NORTH LOGAN CITY
4.0 MG TANK DISTRIBUTION AND SUPPLY PIPELINES PROJECT
ADDENDUM #2

May 6, 2025

RATTLESNAKE HILL 4.0 MG TANK PROJECT

SEI NO. 10635	DESIGNED EL	DRAWN EL	CHECKED SH	SHEET NO. 19 of 000	S3
------------------	----------------	-------------	---------------	------------------------	----

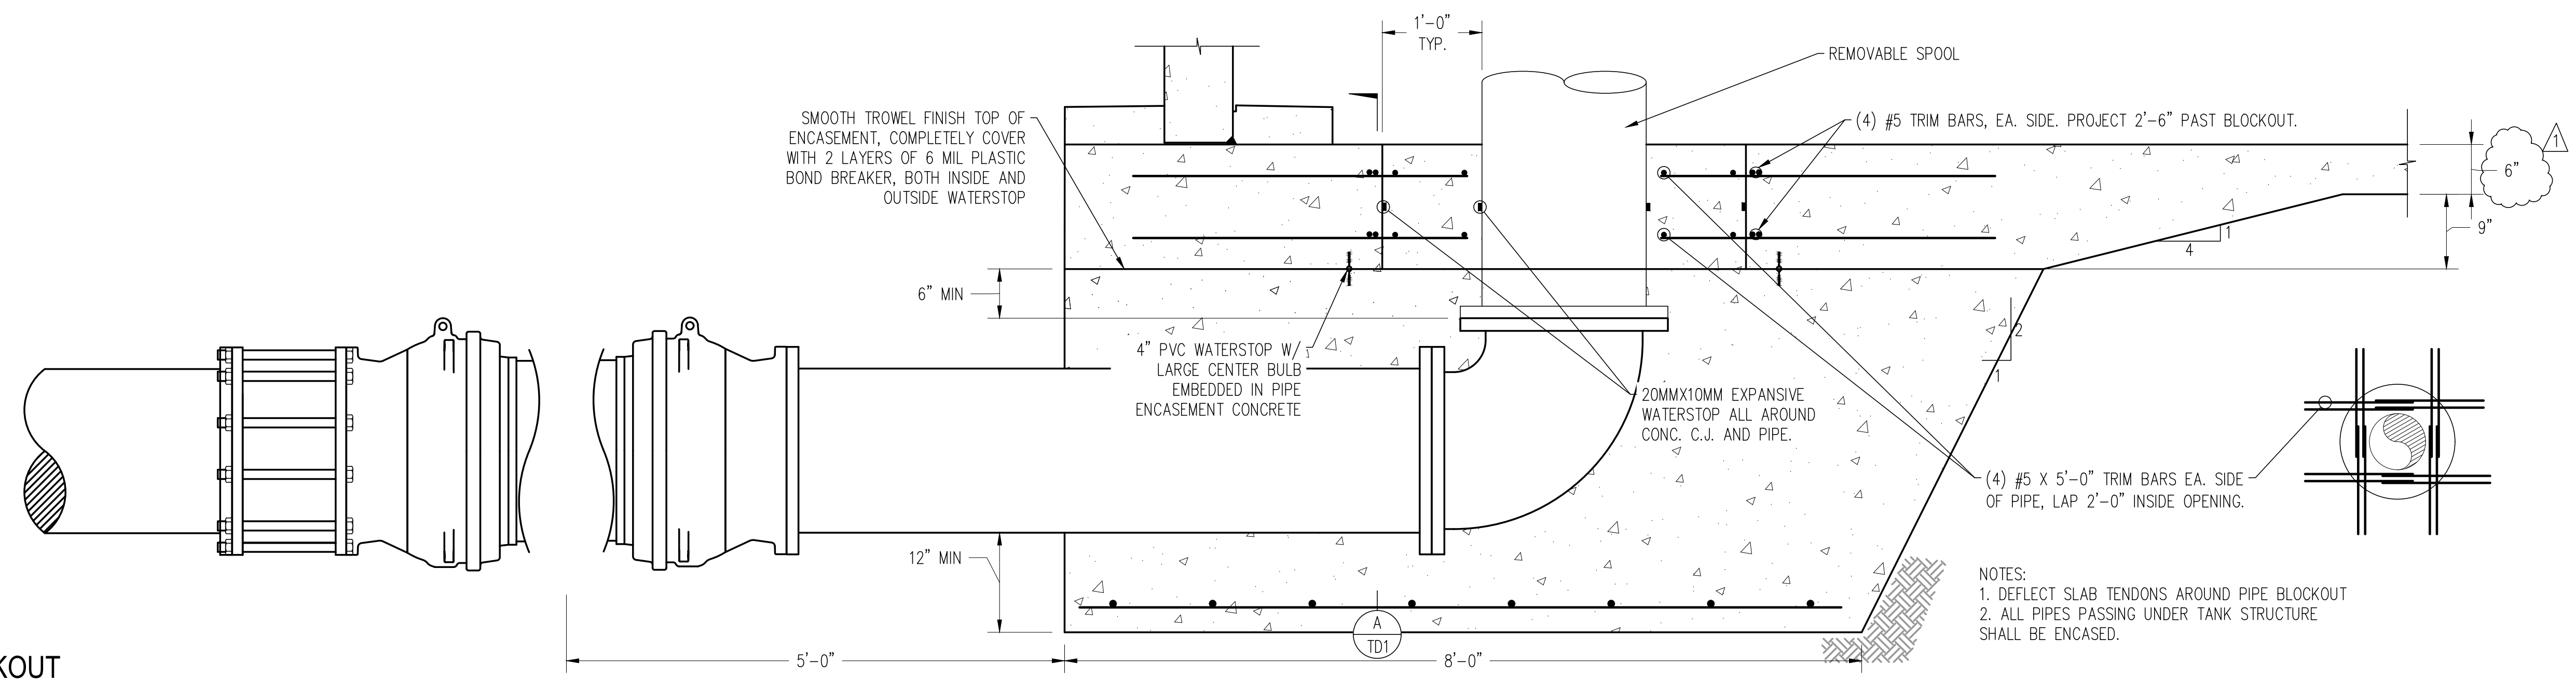
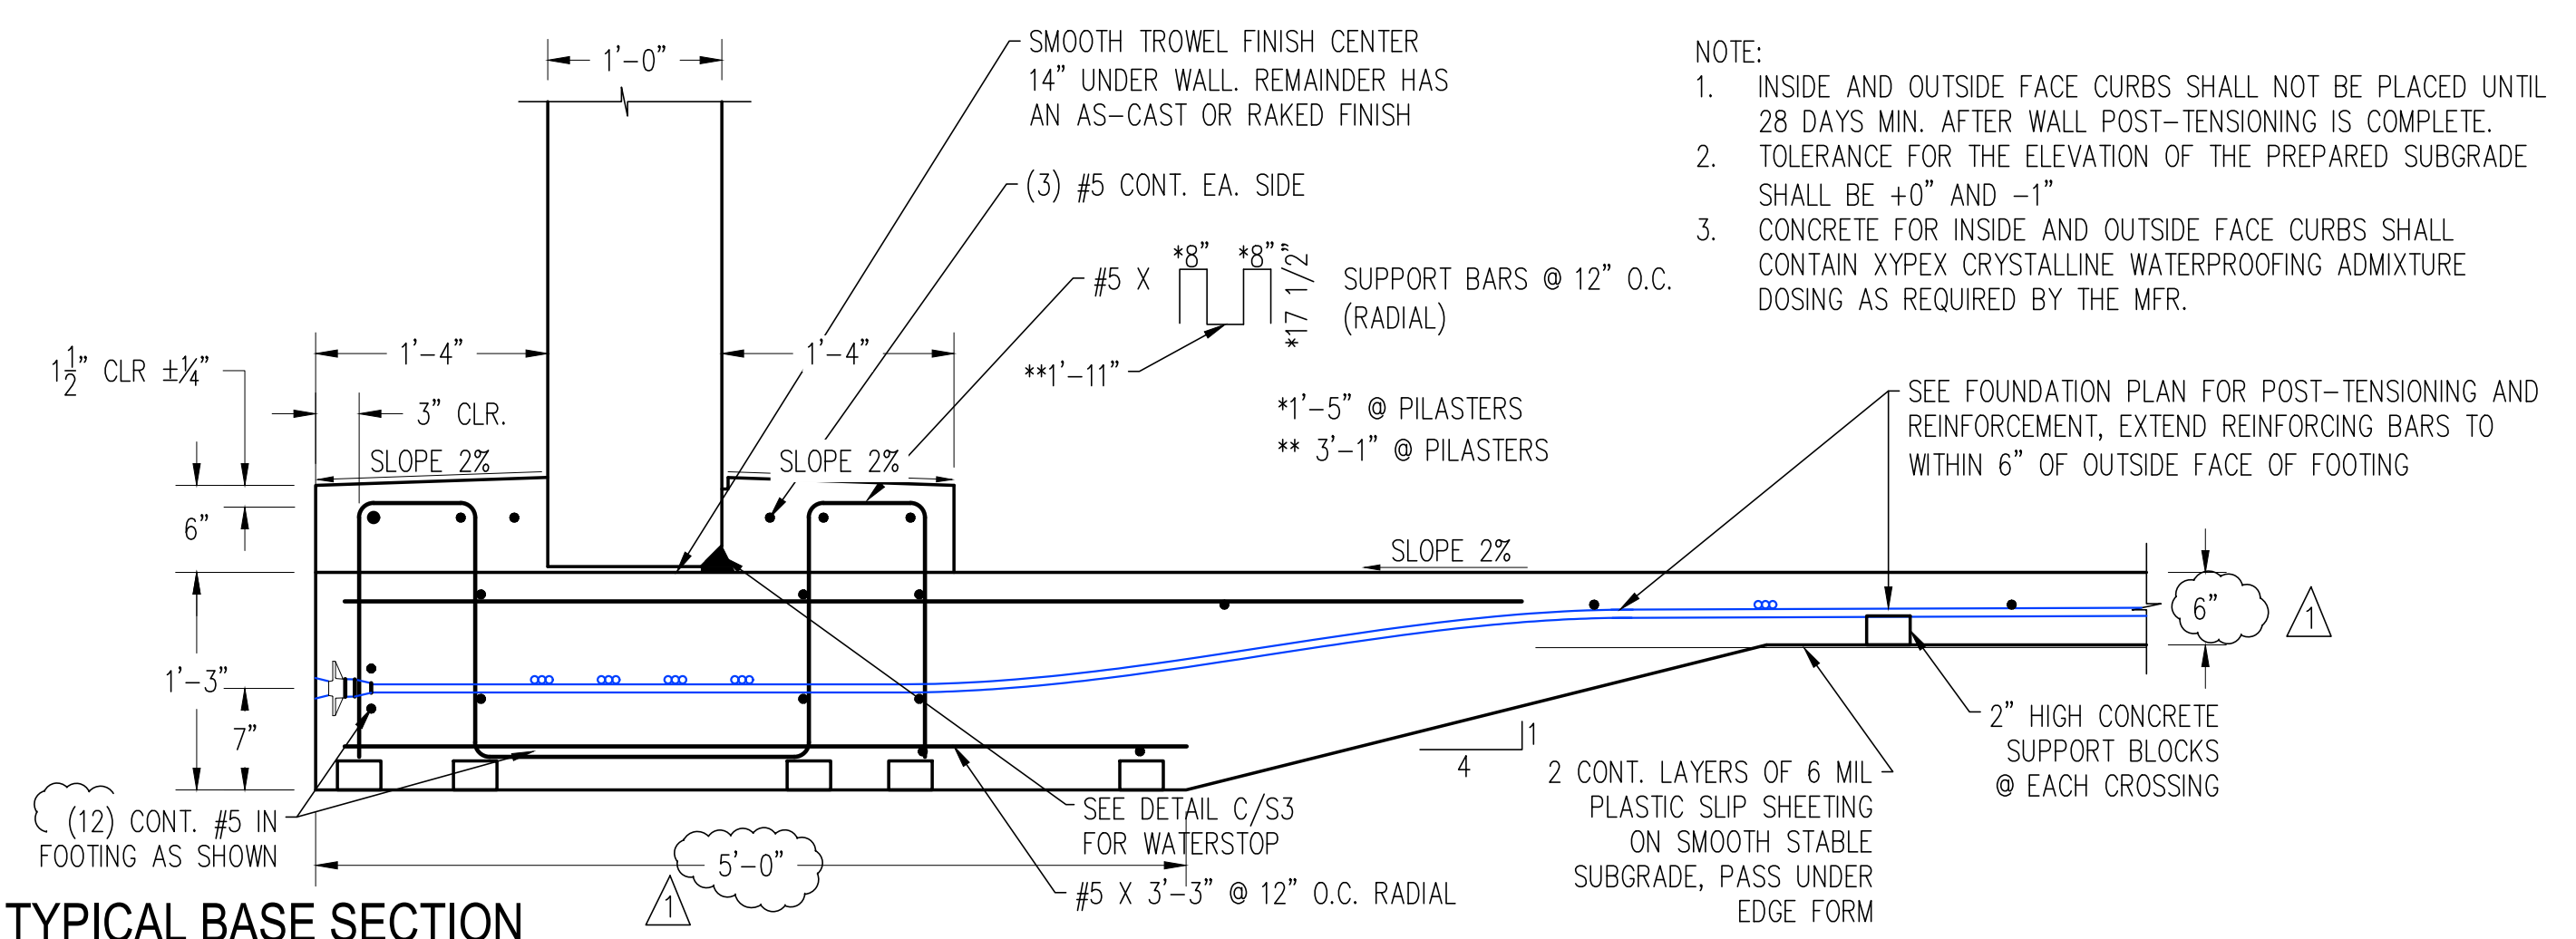
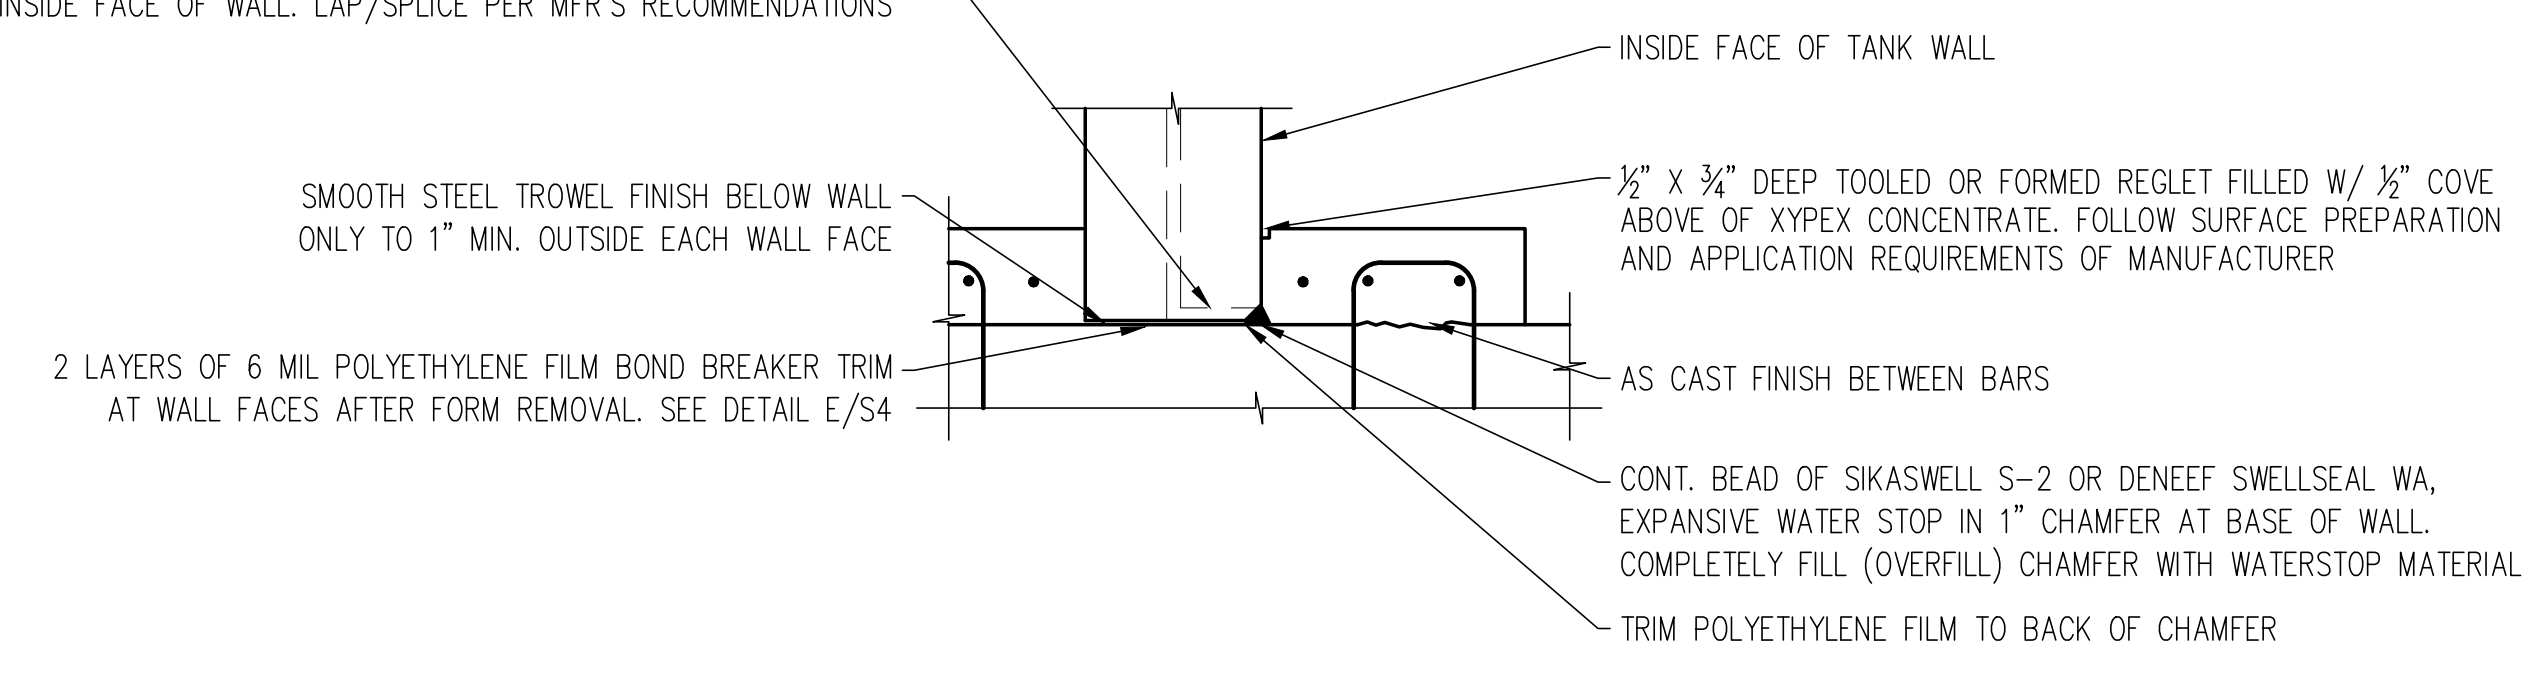
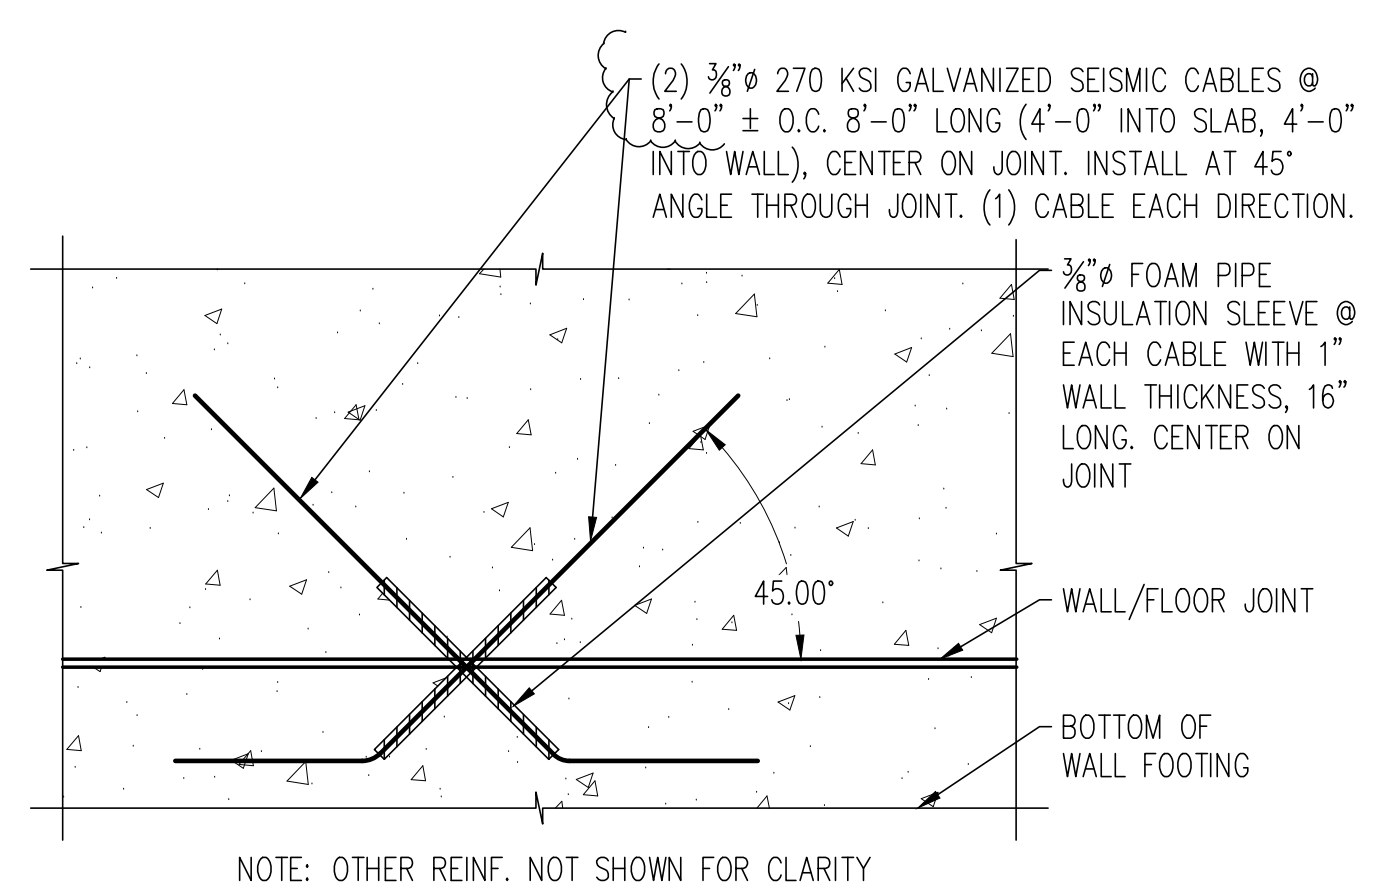
- 1) The concrete floor of the tank will be increased to 6" thick and additional reinforcement both traditional rebar and cable reinforcement has been added. Steve Hansen, the Structural Engineer, has provided the following updated structural sheets to make the alterations needed for the tank.

REV. NO.	COMMENT	DATE
1	SLAB REVISIONS	5/05/25
